ADA Curb Ramp New Construction Inspection Form (Parallel)

Nw 313

24952.54

Nw commercial

PARALLEL RAMP (PL)

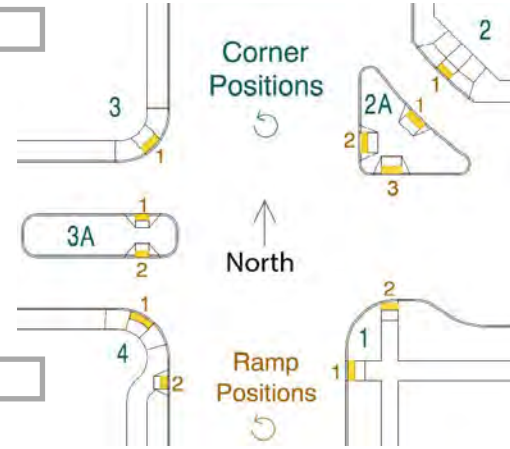
$\geq 5.0'^{*1}$ ☐ $< 5.0'^{*1}$ ☒

TS less than 5 with obstruction IITD
